ENGINEERING ORDER

1. ENGINEERING ORDER NO.	2012C1036-T
DATE:	2010-07-20
PAGE	1 OF 3 PAGES
2. DWG TITLE	VALVE, SOLENOID FUEL AND AIR
3. DWG CAGE CODE	50105
4. DWG NO.	5027-51
5. NEXT ASSY	
6. USED ON	F-16 Aircraft
7. OPR CAGE CODE	98748
DWG SIZE	C
DWG SHEET(S)	1
LATEST DWG REV LTR	B

This EO adds Item Unique Identification (IUID) requirements to the drawing

IDENTIFICATION PLATE
PN 200945069-201

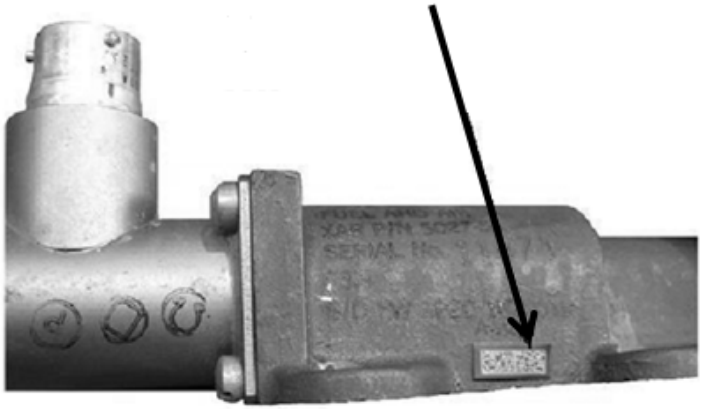
- F-16 Aircraft Fuel and Air Solenoid Valve (PN 5027-51) shall be marked with a Unique Item Identifier (UII). (REF: MIL-STD-130)

- If no UII symbol is present, fabricate new identification plate (200945069-201) to attach to the end item, adjacent to the OEM identification markings as shown in sketch/photo on page 2, AF form 3926.

- After attaching IUID plate to end item, apply a thin overcoat to IUID plate ensuring the plate edges are sealed, using 1A20, 1A33 or equivalent Polyurethane Conformal Coating, per manufacturer's instructions. REF: MIL-I-46058C
